Fort Street Public School / Architectural Design Statement  
Section 4.55 Modification 2- Minor Amendments

Department of Education [SSDA 10340-Mod 2] — REV 06 —11/11/2022

Upper Fort Street, Observatory Hill, Sydney

# 1/ Floor Level amendments

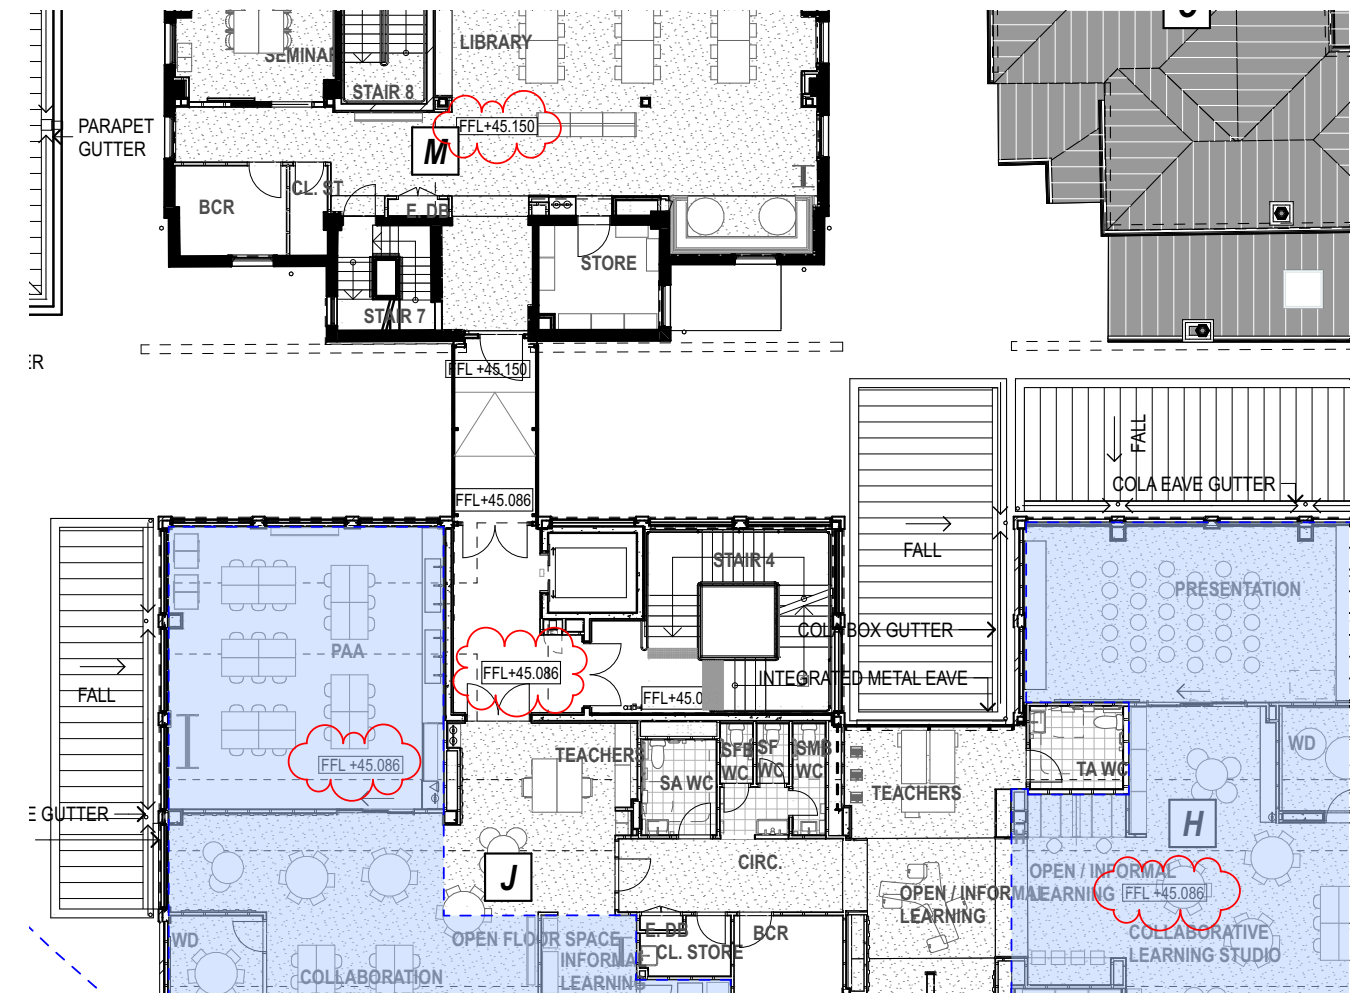
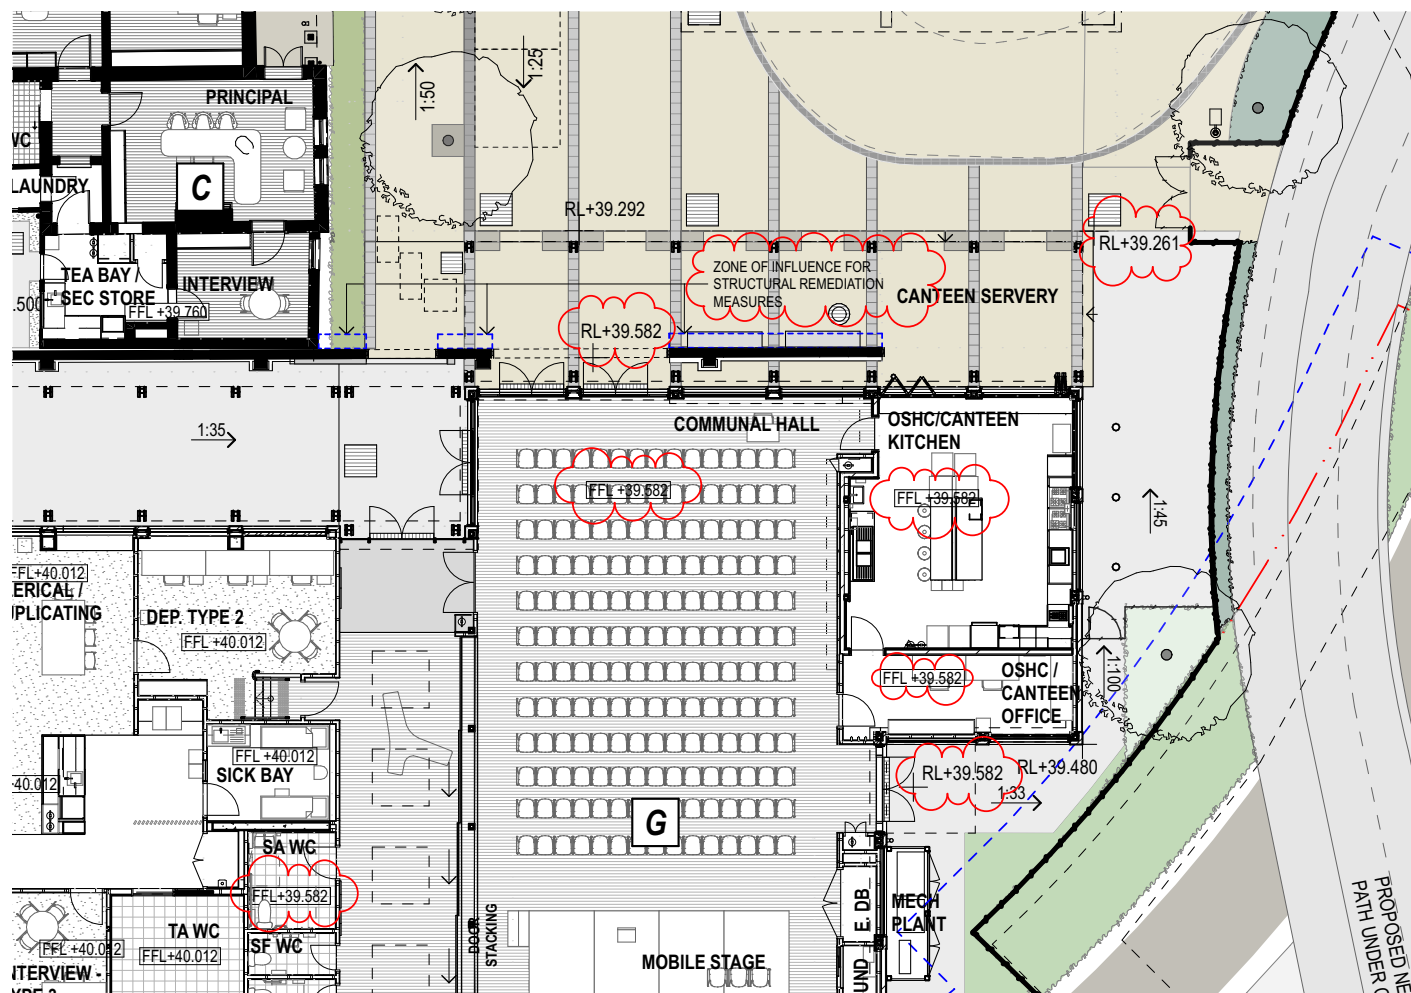
The finished floor levels (FFL) of portions of the new proposed buildings are proposed to be lowered, each by a small dimension:

- Building G** - Hall and Canteen Building (eastern campus building)
  - from **FFL 39.754** to **FFL 39.582**, 172mm decrease (lowered)
- Building H+J** - Administration and Teaching Building (southern campus buildings)
  - Level 1 amended from **FFL 45.172** to **FFL 45.086**, 86mm decrease (lowered)

The proposal for the minor FFL amendment to **Building G** is to reduce the quantum of backfilling, and to provide a taller floor-to-ceiling clearance. External finished levels are also proposed to be lowered, in conjunction with reduction in the grades of connected campus ramps and the like. This improves external ramped connections by reducing the severity of the compliant level changes. The building's overall envelope height is not proposed to change, and the configuration of internal spaces is not proposed to change.

Detailed site surveys and fabric analysis has identified that a small drop in the finished floor level of Level 1 of the campus' southern **Buildings H + J** is required to ensure the transitions and bridge to the existing retained MET building's upper levels is more appropriately matched. The reduction is only proposed to the internal floor level and will not result in any outward change to the volume, height and scale of the approved form. Minor amendments to the articulation of glass facade sills and headers are proposed resulting from the extent of glass facades following the floor level drop. In all other respects the amendment will be intangible externally.

## 2/ Building Envelope amendment

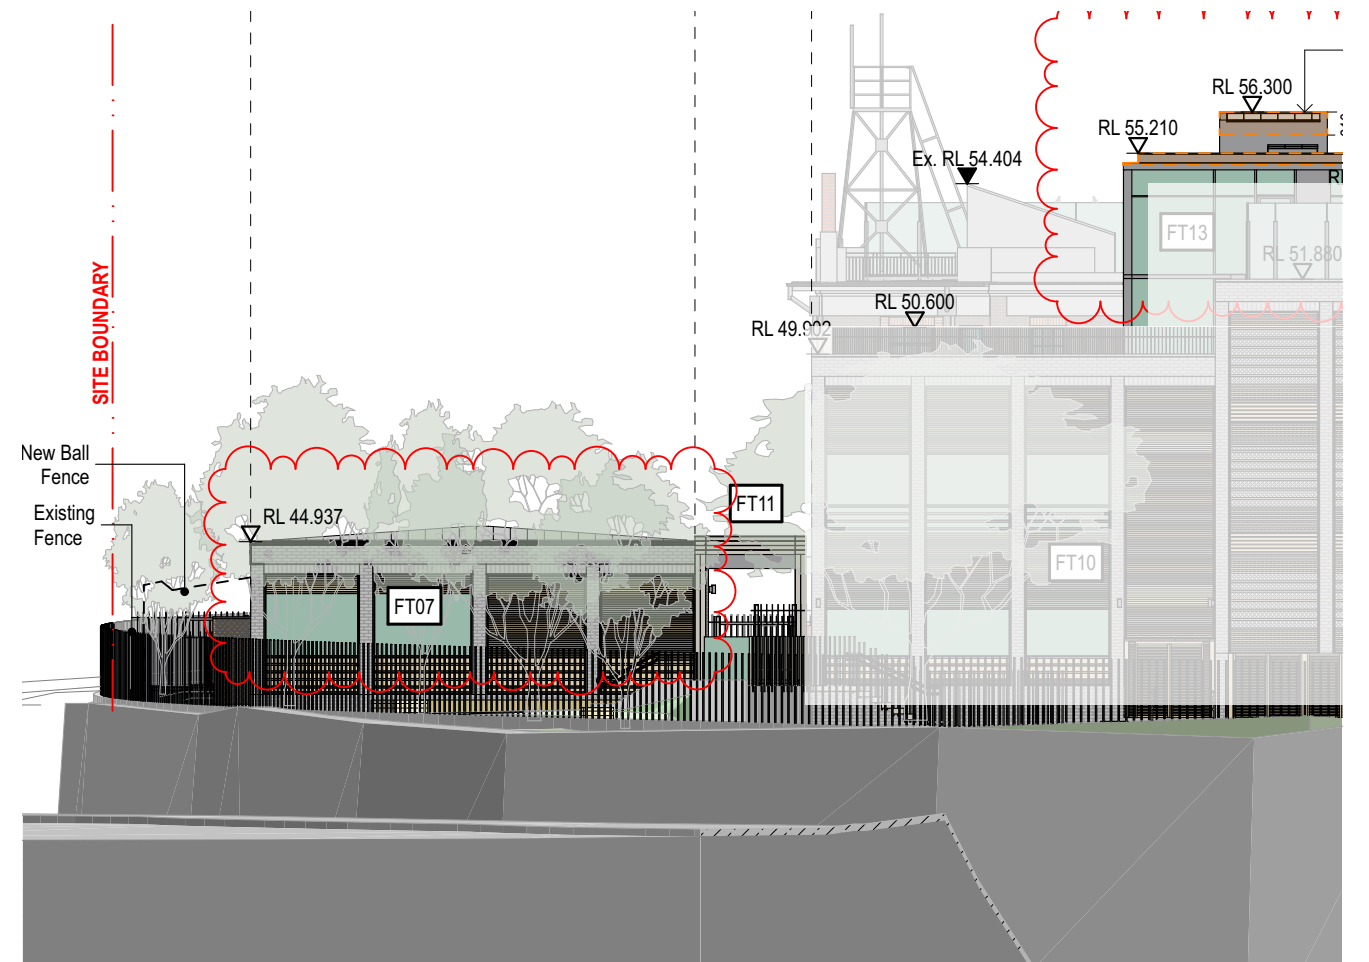
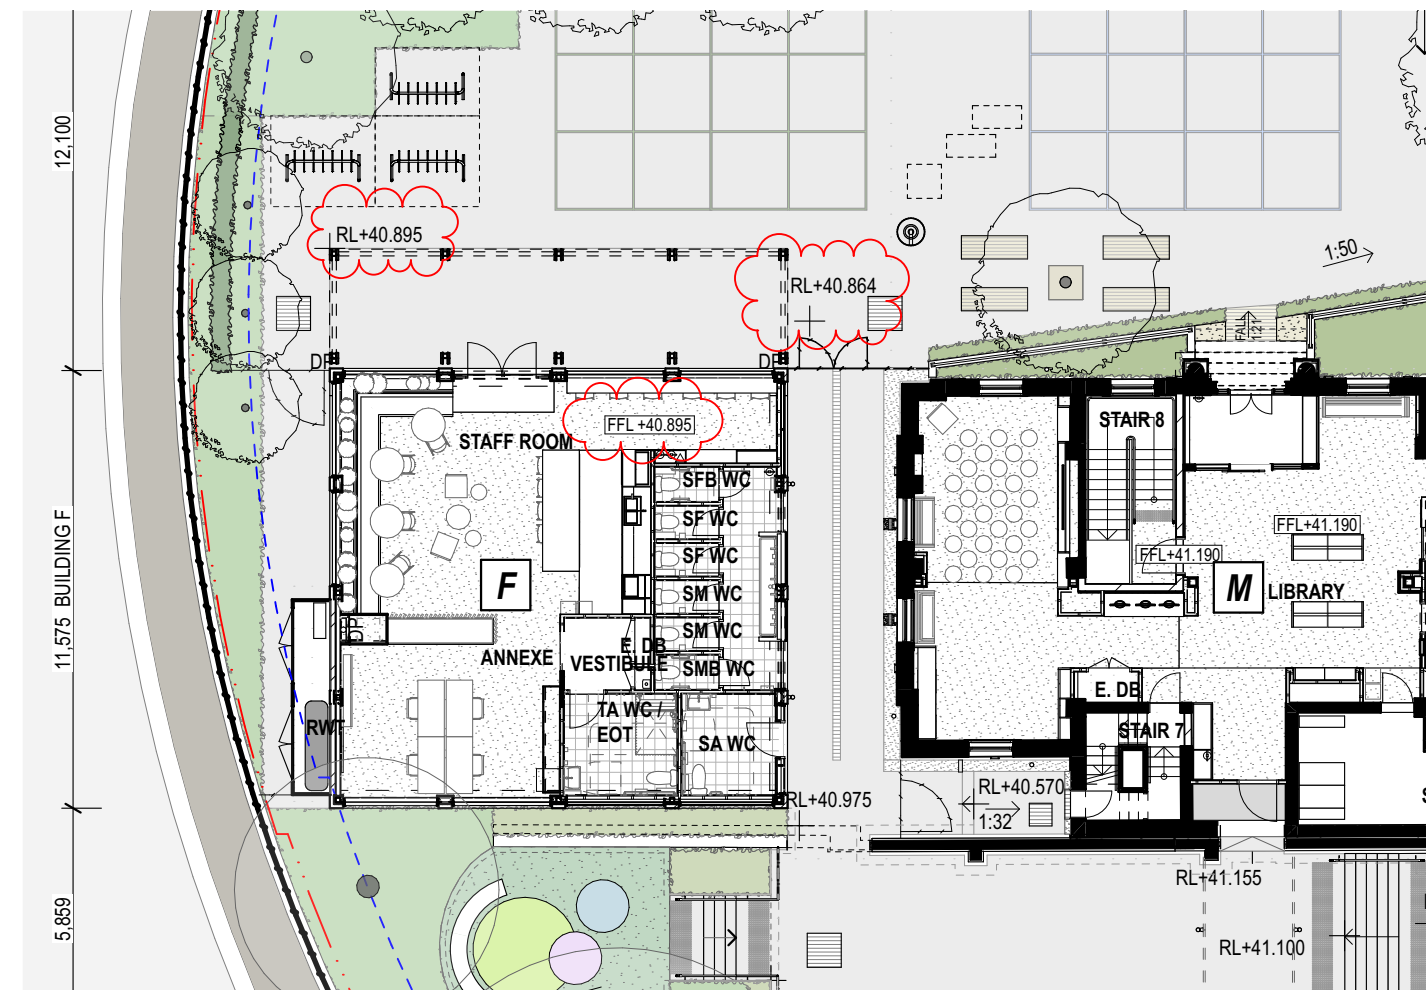
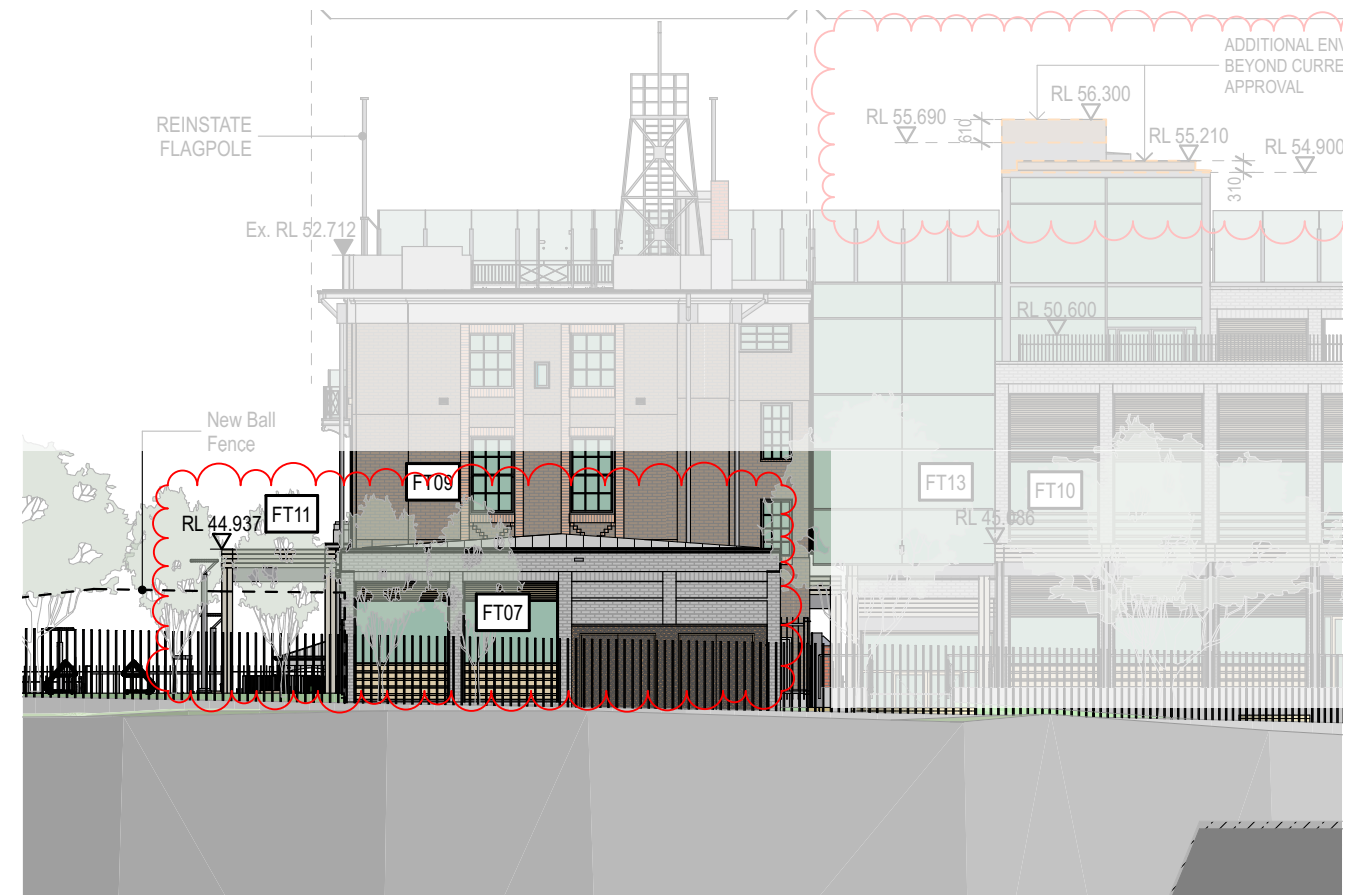
- a. The whole of **Building F** - Staff Annex is proposed to be lowered
- from **FFL 41.155** to **FFL 40.895**
  - parapet **RL 45.197** to **RL 44.937**
  - total decrease = 260mm

Similar to the proposed amendments for FFL to Building G, the FFL of Building F is proposed to be lowered along with adjacent external finished levels. The building's overall envelope height is also proposed to be lowered such that its parapet and roof levels are lower than the approved SSD..

The visibility of the existing heritage buildings is improved by the relative lowering of the new parapet to Building F. This improvement of the new composition enhances the legibility of the lower portions of the MET and its characteristic heritage detailing. Campus amenity and solar access into the western windows of the MET building are improved. As mentioned at item 1/ above, the reduction in backfilling and simplification of material handling on site is also advantageous.

### 3/ Lift overrun amendment

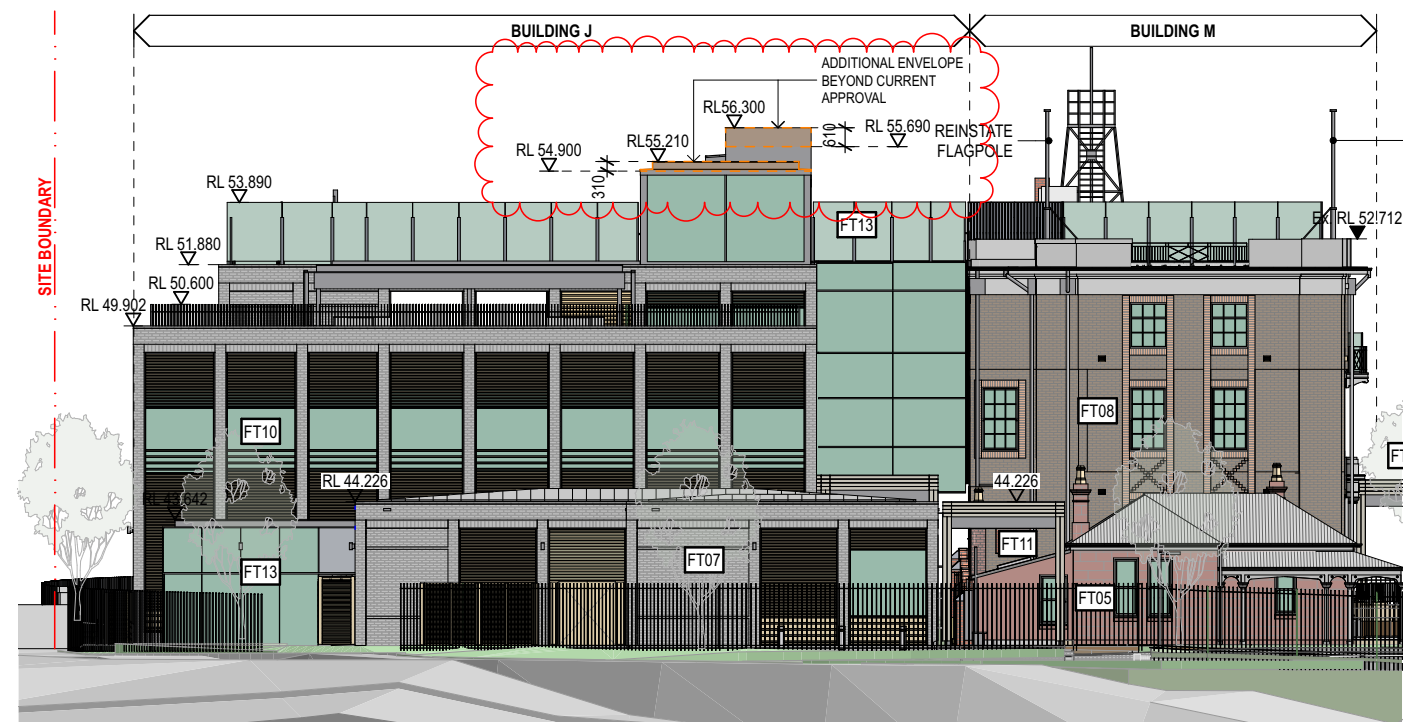
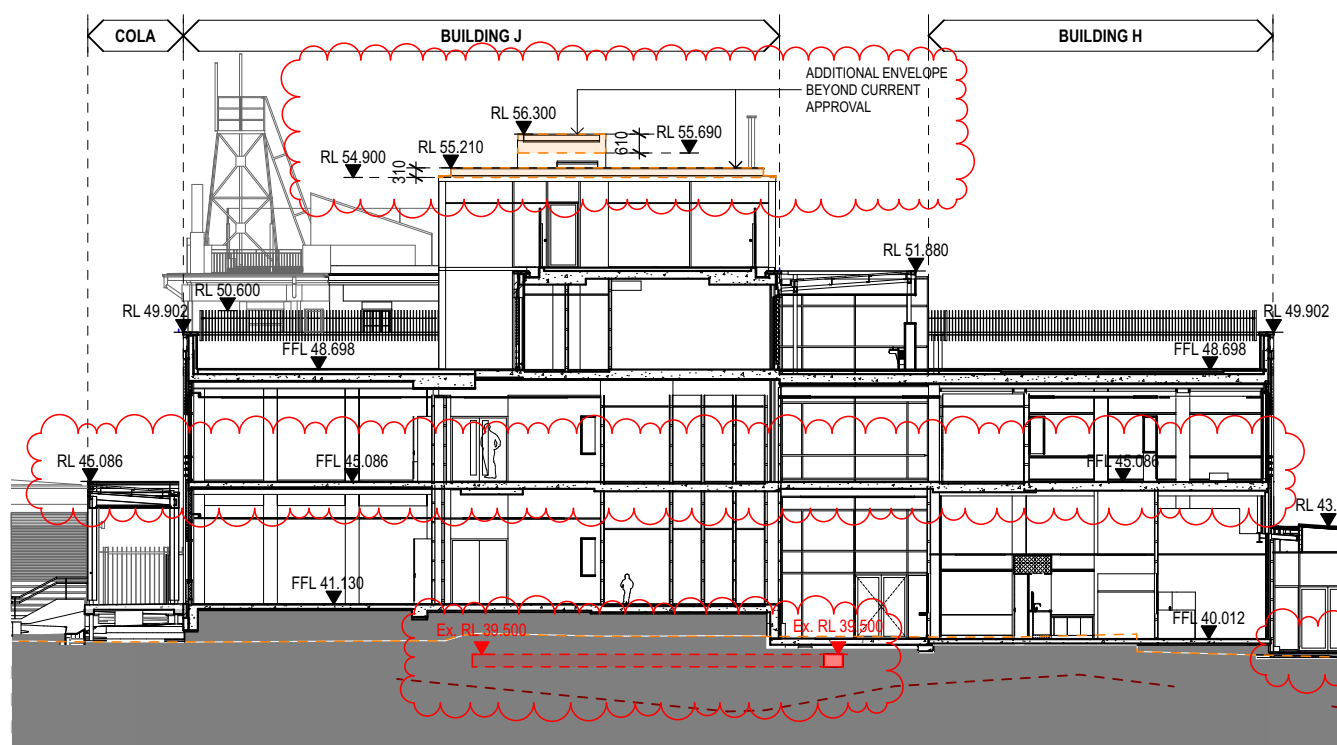
This proposal seeks to make marginal amendments by raising the RLs of the top of the lift shaft and the stair lobby of Building J. It is submitted that these amendments are minor in nature, and their impact upon the architectural qualities and campus amenity of the approved campus are so fine as to be negligible.

- lift shaft roof from **RL 55.690** to **RL 56.300**, 610mm increase
- stair lobby roof - **RL 54.900** to **RL 55.210**, 310mm increase

- structural roof steel detailing and tolerances requiring more vertical dimension to realise conventional roof frame details without increasing relative complexity to achieve the approved envelop
- footprint of the lift shaft and constraints imposed by proximity to adjacent

fabric, further influenced by recently discovered remnant brick drain and footings

View from the north east

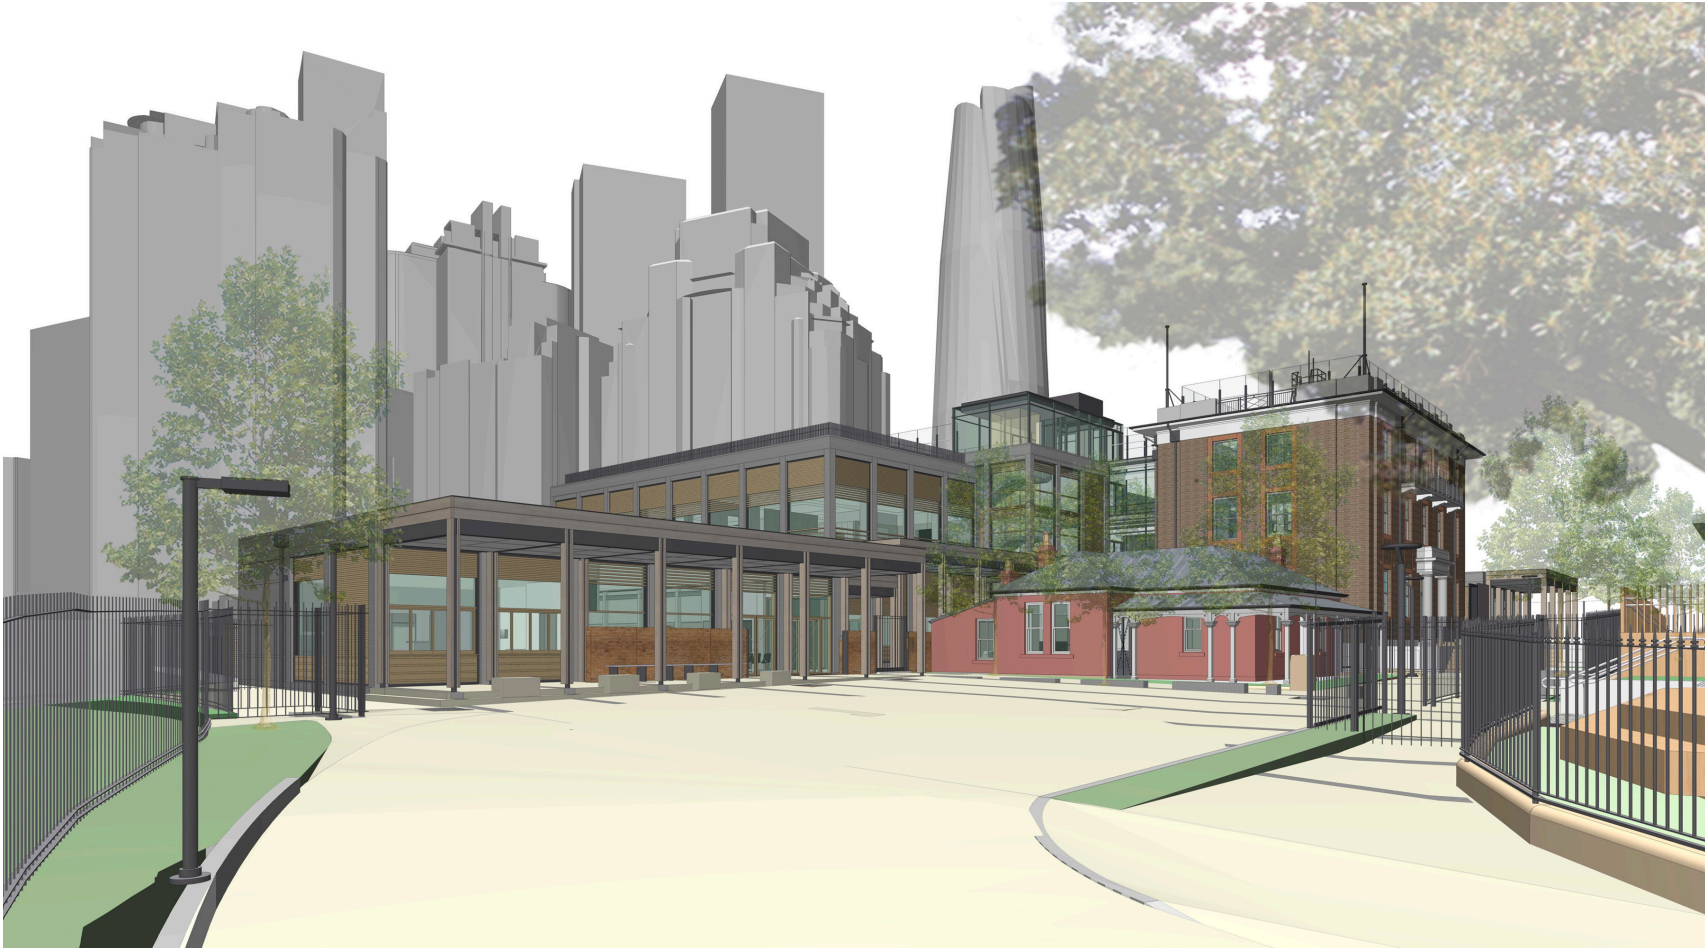
Lift shaft and Stair Lobby raised  
(610 and 310mm respectively)
